Submission RE 38-42 Anderson St and 3 McIntosh St and 2 Day St (SSD-74670720)

Executive summary

Figure 1 Extract from proponent's Fig 4. The shown shared path/on road route along Orchard Rd to the station does not appear to be recognised by on road or wayfinding signage, i.e. is a route on paper only.

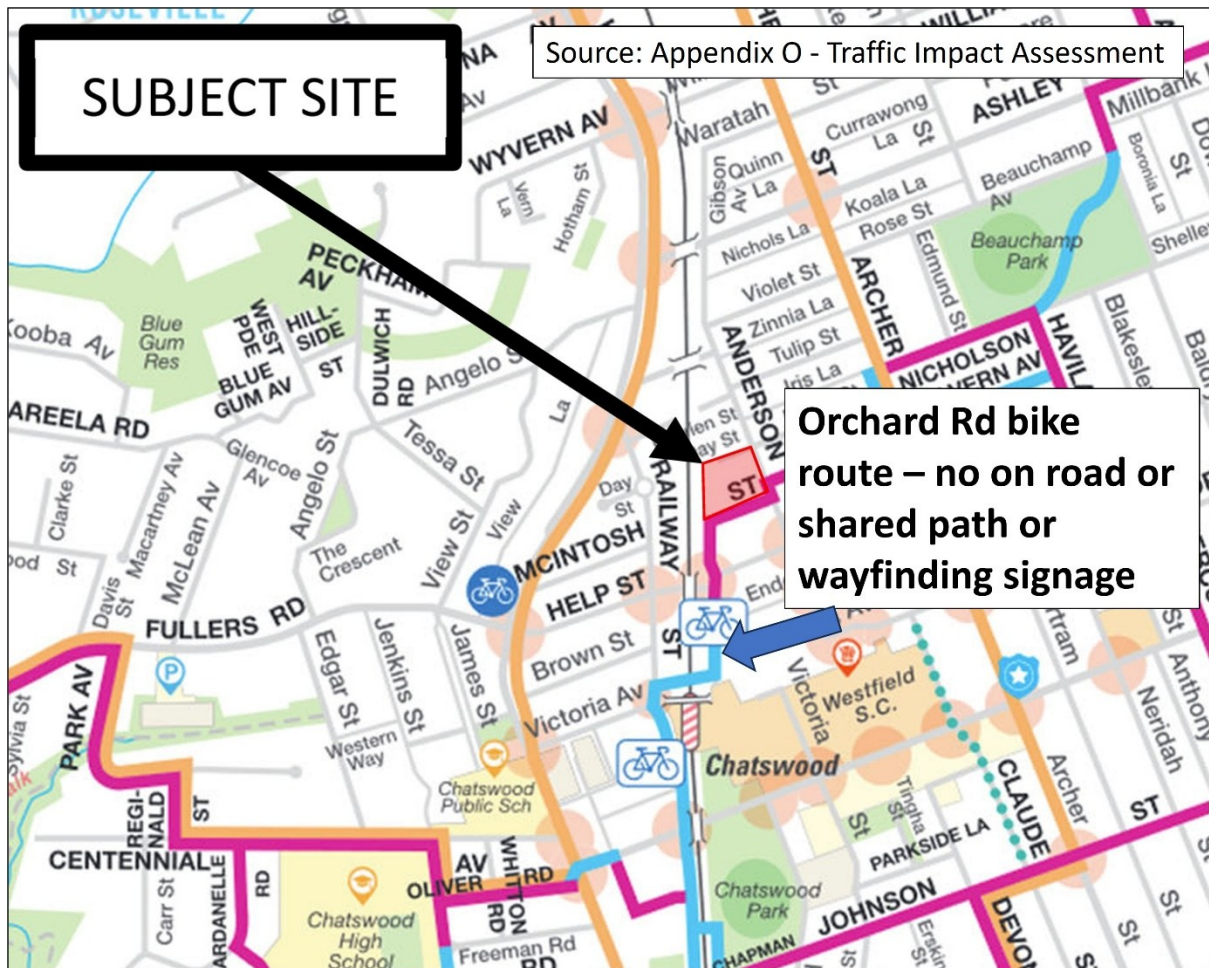
The provided map (TIA Fig 4) indicates an on road/shared path bike route to the station along Orchard Rd. The writer is not aware of any local on road or wayfinding signage that supports that bike route/shared path characterisation (Fig 1).

Figure 2 NSW Government cycleway finder map (not referenced by proponent). The map shows a bike route connection to the station via Railway St. The Railway St route is not defined by actual on road or wayfinding signage so is a route on paper only.

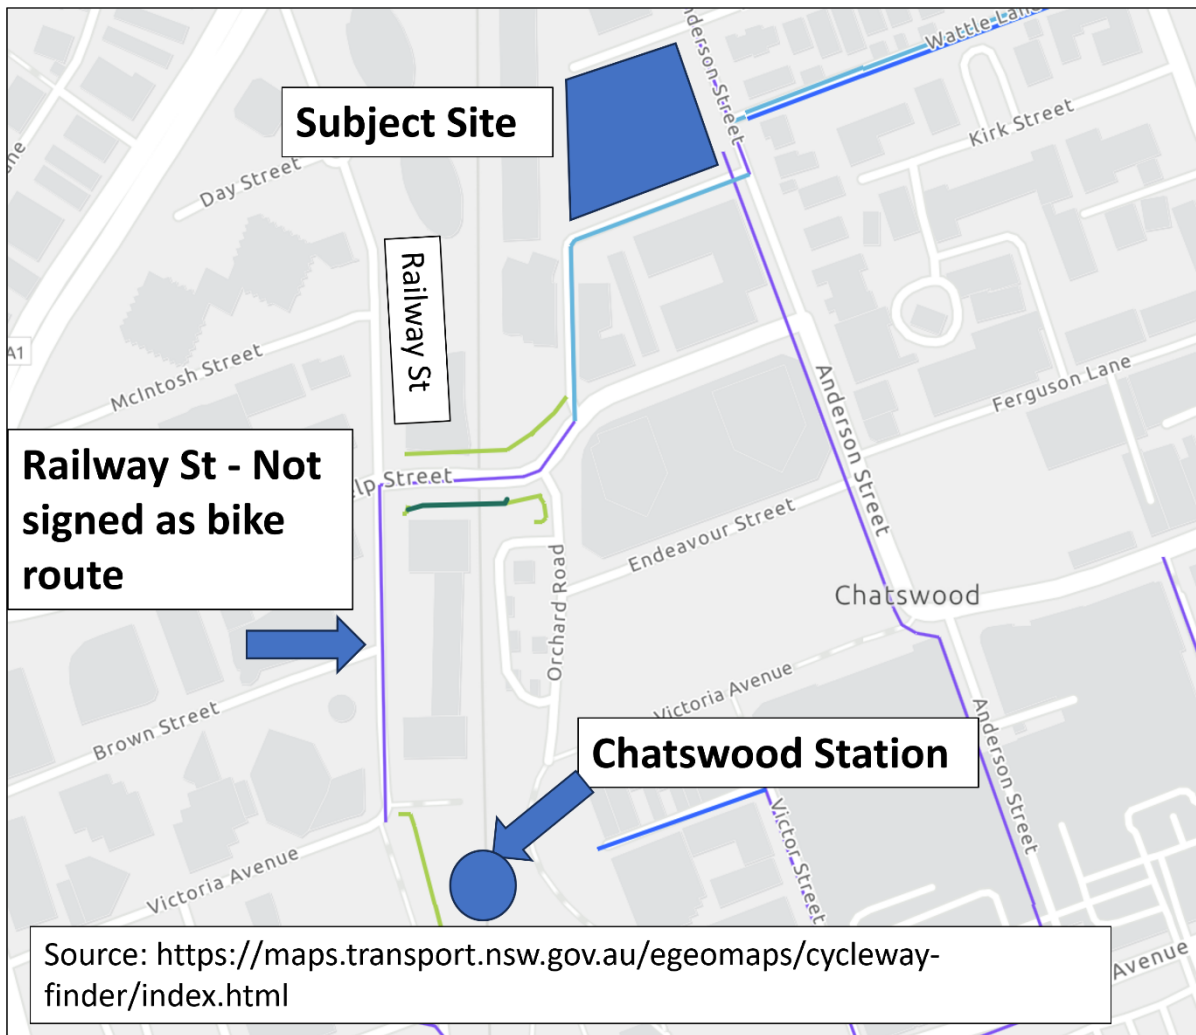
The NSW Government cycleway finder map (<https://maps.transport.nsw.gov.au/egeomaps/cycleway-finder/index.html>) - not referred to by the proponent, shows an alternative bike route from Cambridge Lane to the station via Help St and Railway St. The indicated Railway St bike route (on

road) lacks any actual on road and wayfinding signage and is not recognisable as a bike route, either (Fig 2).

Figure 6 The bike lane channel at the corner of McIntosh St and Cambridge Lane appears to be narrower than regulated.

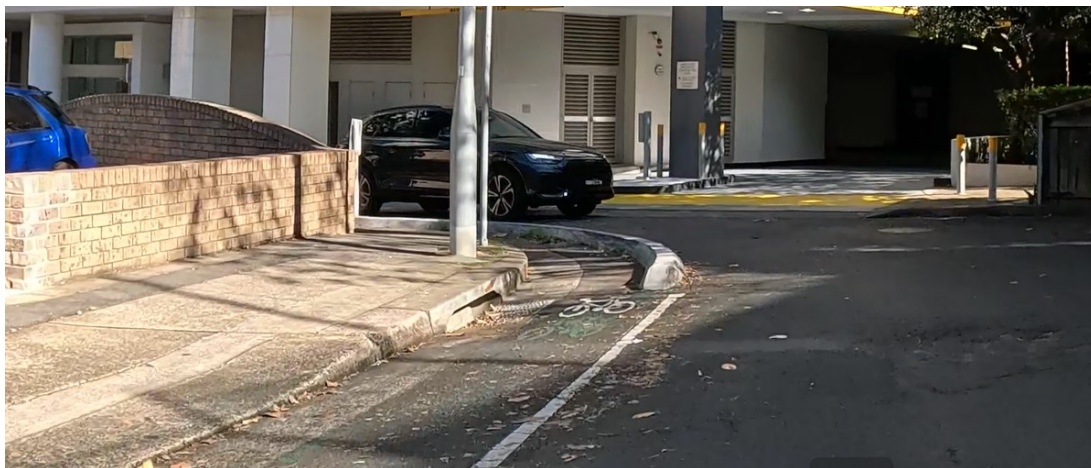
- e) The contraflow bike lane channel at the corner of Cambridge Lane and MacIntosh St appears to be narrower than is safe or regulated (Fig 6)
- f) The contraflow lane is easily blocked by bins (Fig 7) and traffic (Fig 8)

Figure 10 Cyclists may turn right from Cambridge Lane to Help St shared path across incoming traffic. There is inadequate signage to warn incoming traffic.

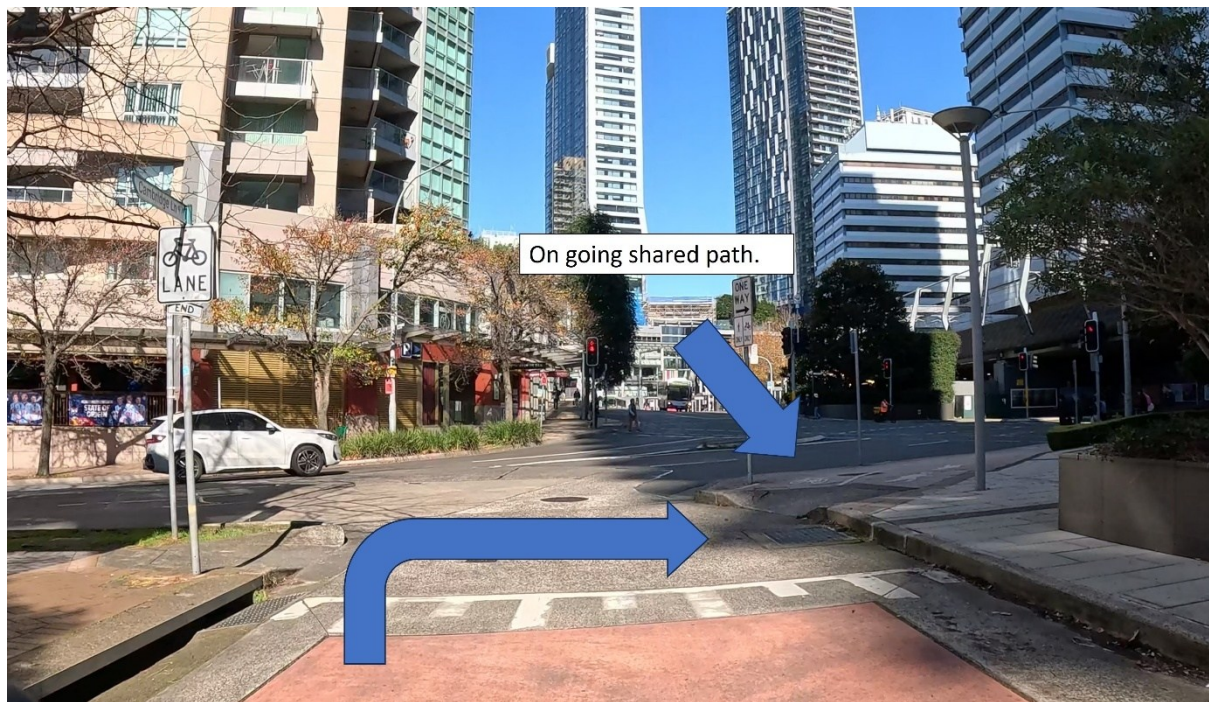
- h) At the Help St end of Cambridge Lane a cyclist will typically turn right to the Help St shared path. This is across the path of vehicles entering the lane from Help St and unsafe. There is inadequate signage alerting motorists entering from Help St to the potential presence of cyclists riding in the opposite direction.

Figure 11 Car entry data, Chatswood Chase car park, from Willoughby Council Traffic Committee April 2025 meeting agenda.

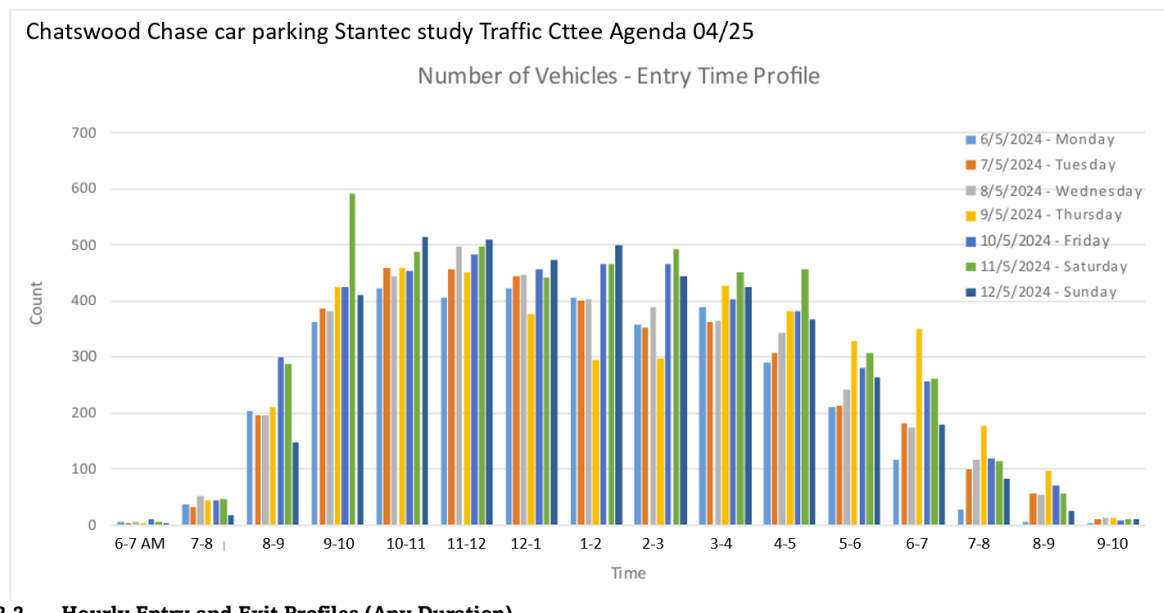
As is widely acknowledged, Chatswood is a significant retail centre, and local traffic is dominantly shoppers rather than, say, people getting to work. Various public and shopping centre car parks around Chatswood CBD accommodate almost 6,000 cars. An analysis of car park entry and exit data provided by the Chatswood Chase shopping centre owners, included in the April 2025 agenda of Willoughby Council Traffic Committee, shows that the peak morning retail traffic is in the time zone 10:00 am to noon, when around twice as many cars/h enter the car park, than during the 8:00 – 9:00

am period (Fig 11). The TIA appears to refer to a 8:00 am to 9:00 am peak hour (eg TIA Fig 14).

According to the TIA, with respect to traffic count surveys done to support the traffic analysis: “The surveys were undertaken between 7:00am and 9:00am and between 2:30pm and 6:00pm on Thursday 19 November 2022.” The weekday am peak period indicated by the Chatswood Chase car park data was thus not surveyed. The key streets in the traffic survey, Help St and Anderson St, are both important streets for vehicles entering Chatswood for retail purposes, so it can be reliably concluded that the peak am traffic time interval was not sampled, and the traffic rates mentioned in the TIA are likely only about half the true peak volumes. The TIA is thus of extremely limited value or no value at all in discussing peak hour traffic.

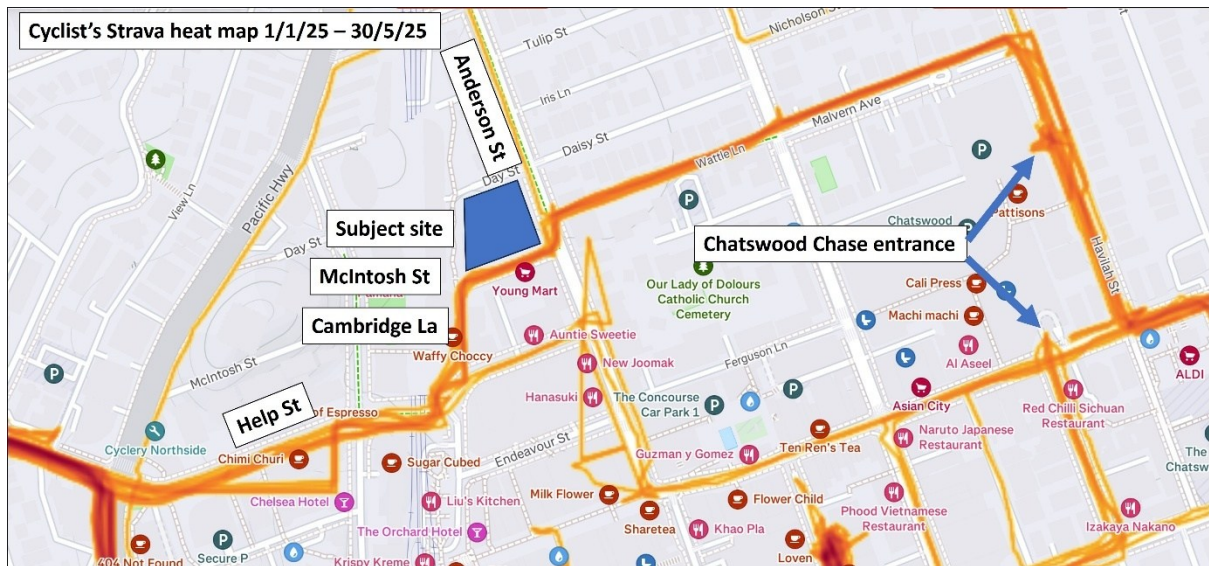
While there are bike routes along Anderson St, McIntosh St, Help St, and Cambridge Lane, it appears that no attempt has been made to contact cycling groups such as Bike NSW or Bike North for comment on the likely impact of the development on cyclists. It is noted that all of these streets provide the bike route link from Chatswood Chase via Malvern Ave and Wattle La to streets west of the railway line and further west down Fullers Rd. A cyclist’s Strava heat map (for period 1/1/25 – 30/5/25, Fig 12) shows that cyclist’s street usage. The denser orange traces on that map reflect greater route usage, with significant usage of Cambridge Lane and McIntosh St. (GPS errors on the map are likely due to satellite signal dropout from shielding by existing high buildings).

Figure 9 Strava heat map of cyclist's rides - 1/1/25- 30/5/25, showing usage of subject side ingress/egress roads in relation to Chatswood Chase shopping centre. The density of the orange lines indicates the relative frequency of usage of a road/route. McIntosh St and Cambridge Lane are regularly used.
